Need For Replacement of High-Voltage Battery On Vehicles Up to Model Year 2024: Observe Specified Procedure (02/25)

Model Line: **Taycan (Y1A/Y1B/Y1C)**

Concerns: **Replacing the high-voltage battery**

Cause: **The previous high-voltage battery for the Porsche Taycan from model years 2020 - 2024 is no longer available.**

Component overview

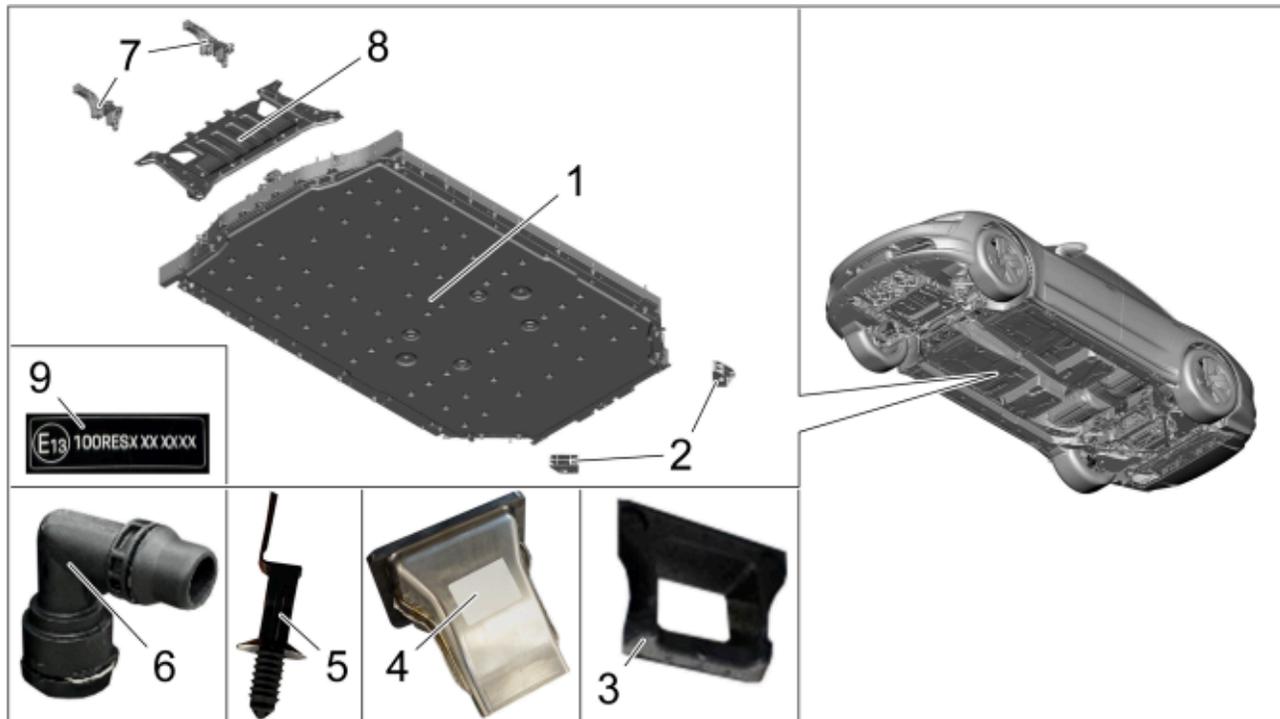
- 1 – High-voltage battery
- 2 – Mounting bracket **(change)**
- 3 – Acoustic seal
- 4 – Air duct (only for vehicles with country of delivery China)
- 5 – Cable tie with holder (only for vehicles with electrically active roll stabilization/M-no. 1P7), **2 piece(s) (replacement)**
- 6 – Coolant nozzle, **2 piece(s)**
- 7 – Anti-roll bar support on left and right, with rubber bearing **(replacement)**
- 8 – Front axle support rear section **(replacement)**
- 9 – Information sign/E-number label

Action: If the previous high-voltage battery needs to be replaced, replace it with a high-voltage battery from model year 2025 onwards.

Serial number (example)

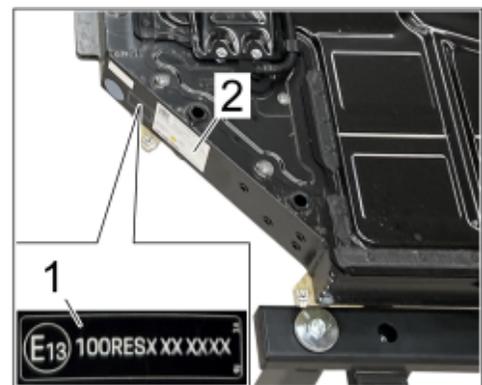
2 Photograph the type plate of the previously installed and new high-voltage battery and note down the serial numbers.

E-number label

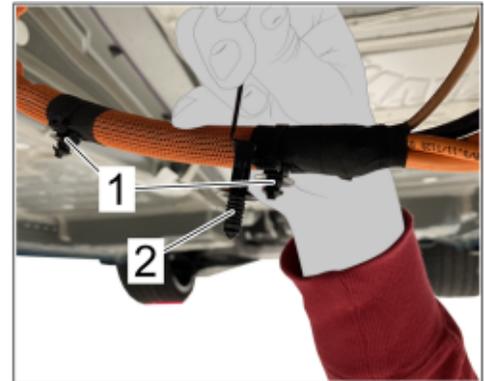
3 Affix E-number label ⇒ Affix E-number label -1- next to type plate ⇒ Affix E-number label -2- to new high-voltage battery.

The E-number label is only required if the E-number is **not** present on the type plate of the high-voltage battery.

Change mounting bracket

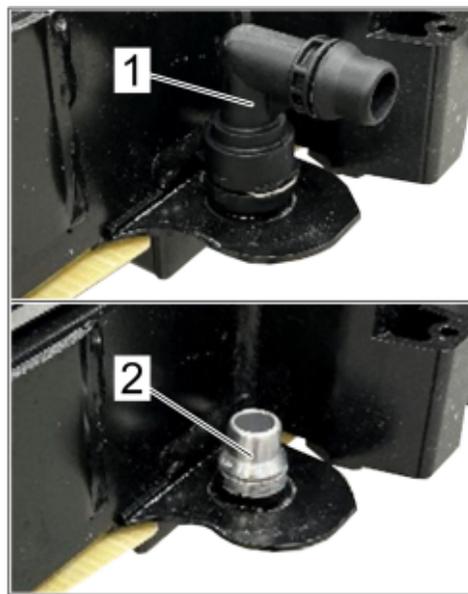
- 5 Change both mounting brackets ⇒ *Change mounting bracket -1-* of the removed high-voltage battery to the new high-voltage battery, while screwing in screws to the system by hand.

The screws of the mounting brackets are only tightened to the high-voltage battery when installed.

Replace anti-roll bar fastening

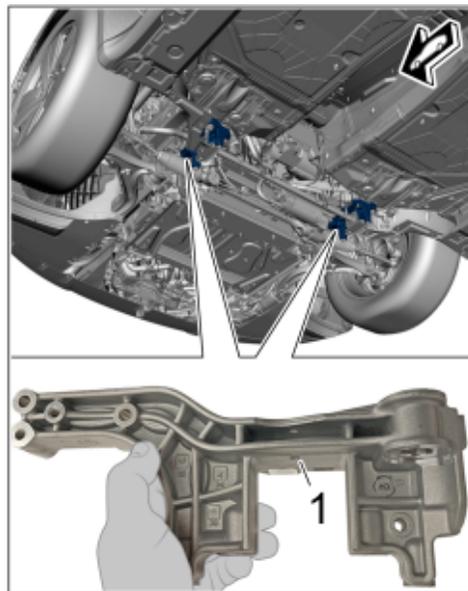
- 7 Replace anti-roll bar fastenings ⇒ *Replace anti-roll bar fastening -1-* with fastenings with model year 2025 component status, replacing rubber bearings.

Screw points for front cover

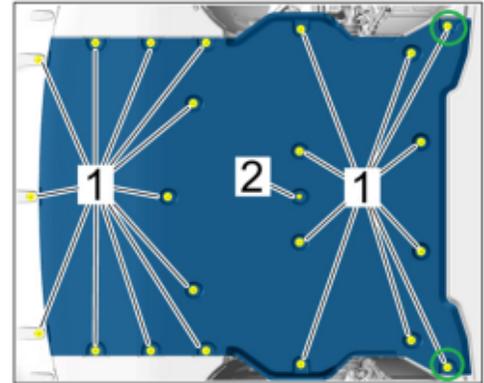
When assembling the front cover, make sure that the two screw connections are ⇒ *Screw points for front cover* -**green circle**- first fastened at the rear in the direction of travel.

It may be necessary to rework the specified screw points slightly for mounting the front cover. ⇒ *Screw point reworked*
